A New Residence For Jeff, Beth & Matt Fischer

Lot 5 - Hermitage - High Springs, Florida

Review for Code Compliance
Universal Engineering Science

Bonus Room Floor Plan

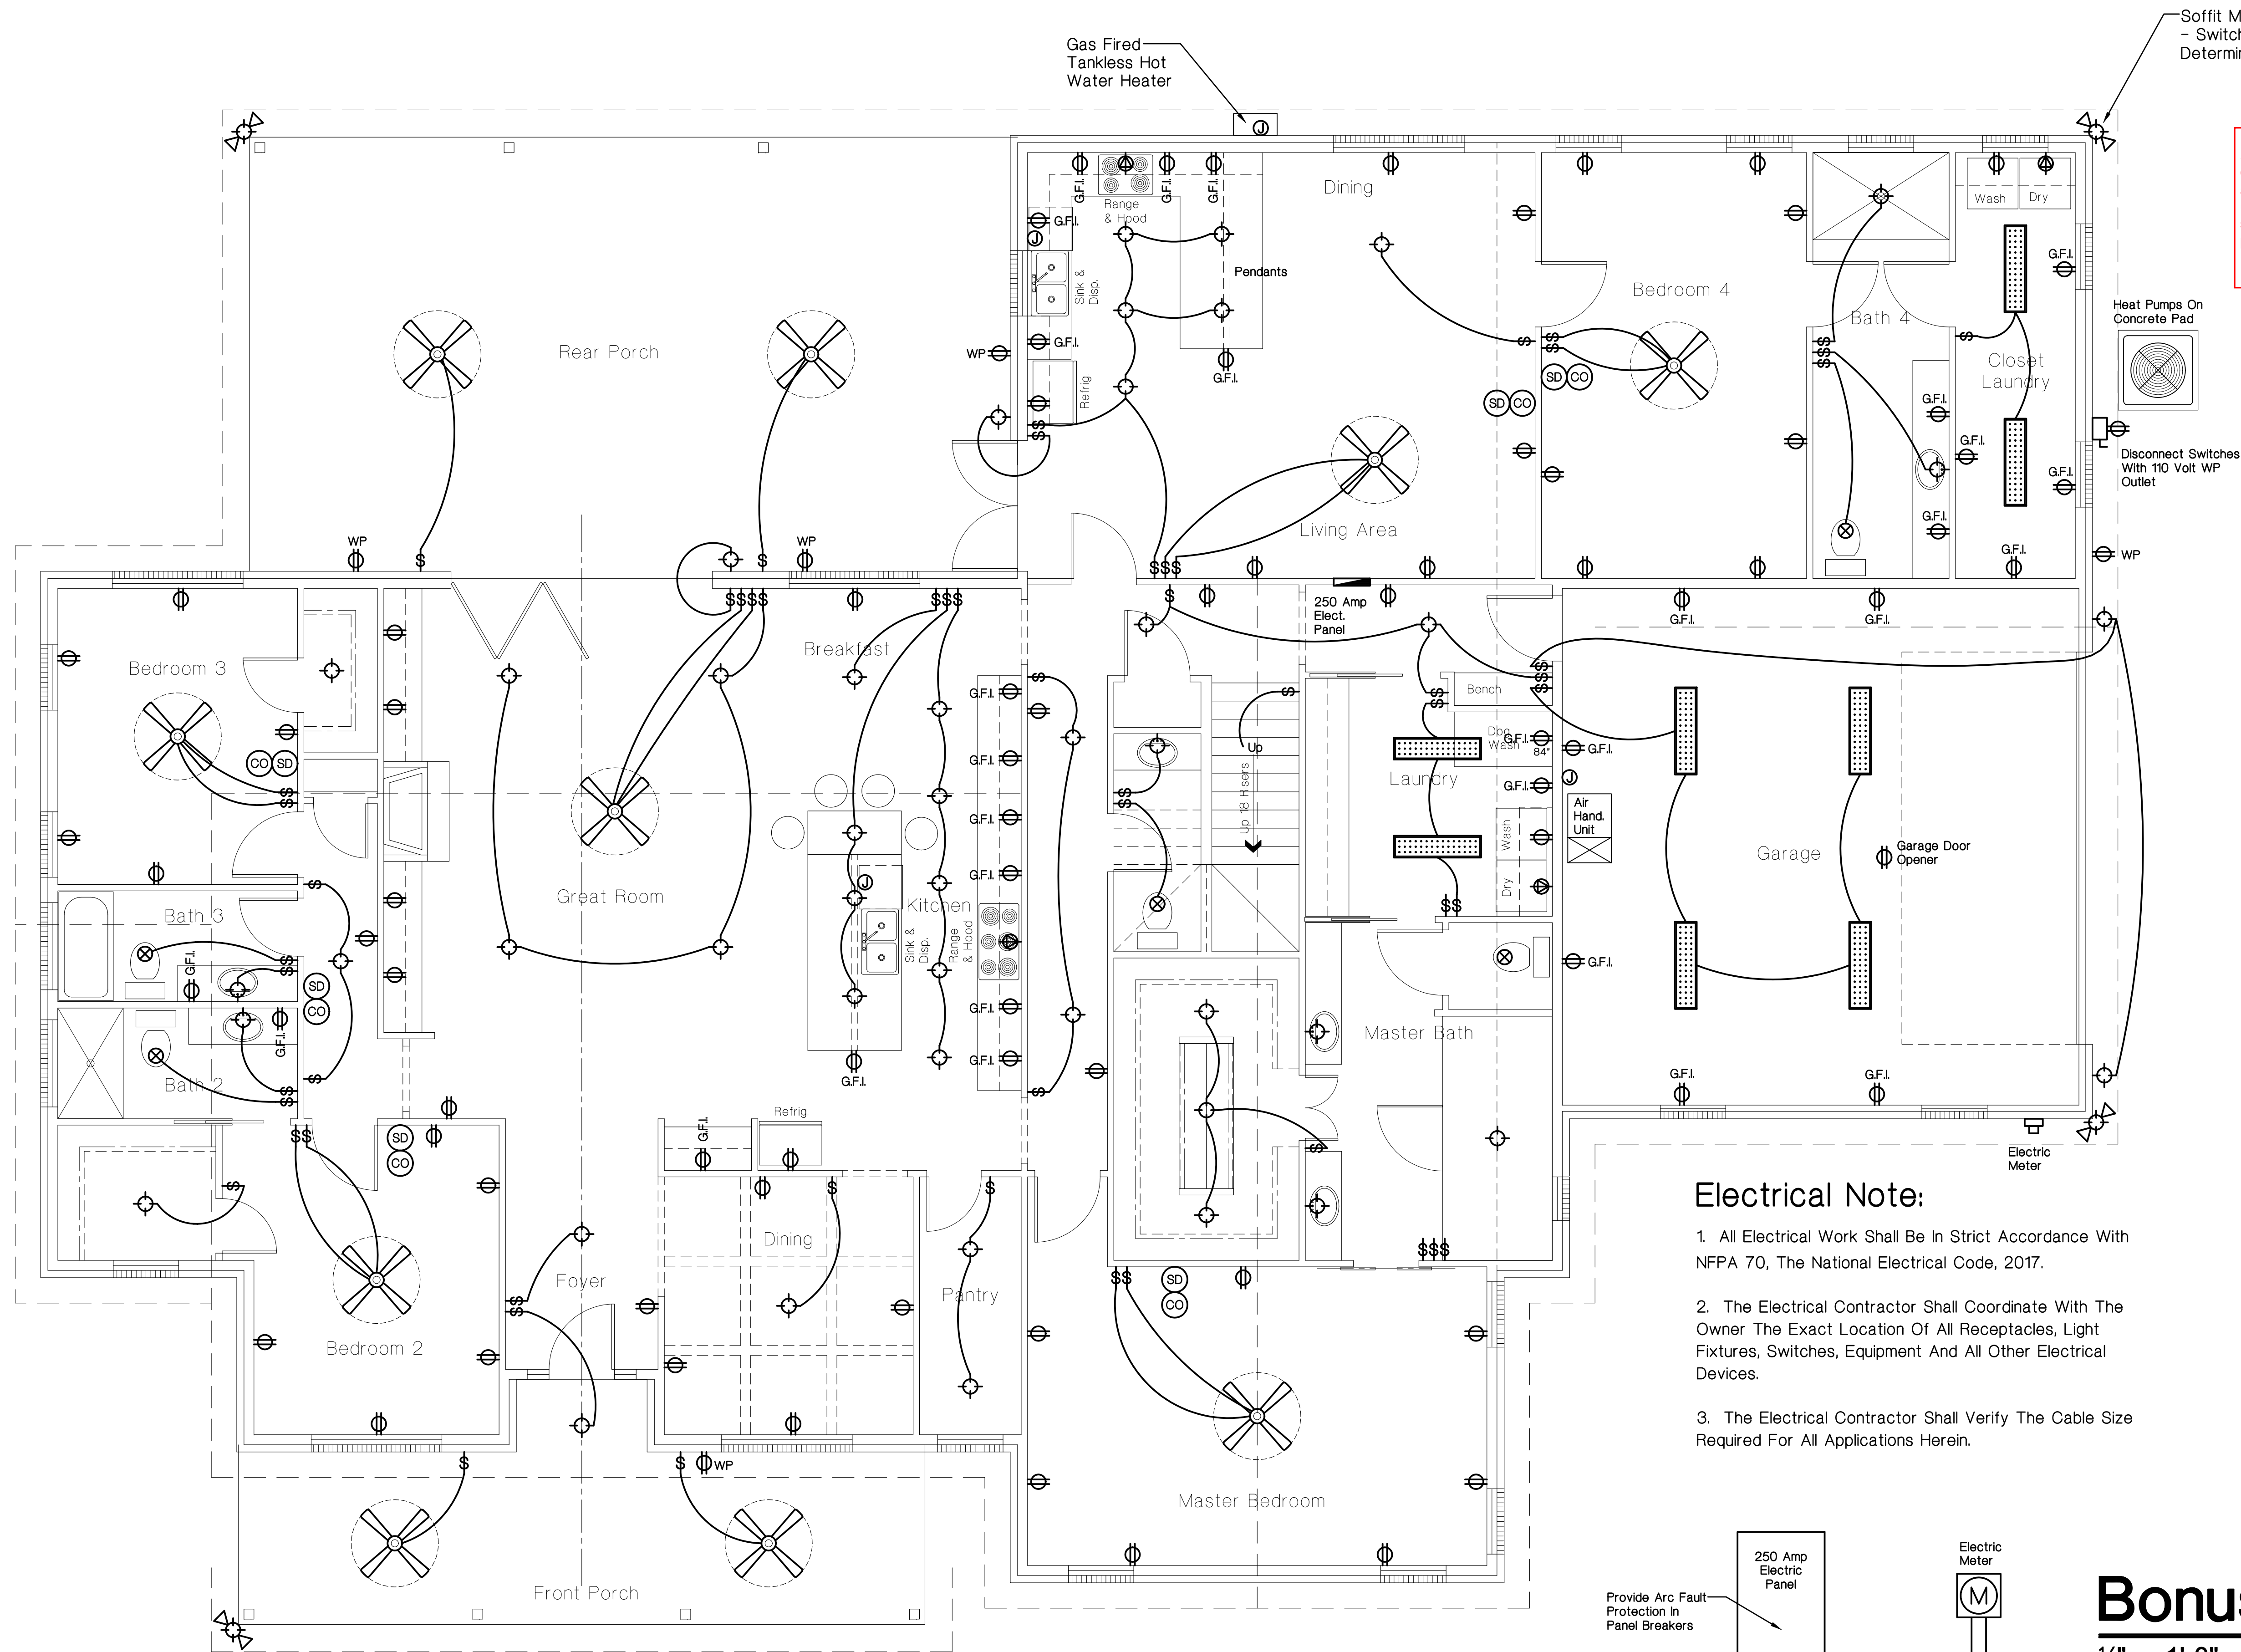
R314.3 Location.
Smoke alarms shall be installed in the following locations:
On each additional story of the dwelling, including basements and habitable attics and not including crawl spaces and uninhabitable attics. In dwellings or dwelling units with split levels and without an intervening door between the adjacent levels, a smoke alarm installed on the upper level shall suffice for the adjacent lower level provided that the lower level is less than one full story below the upper level.
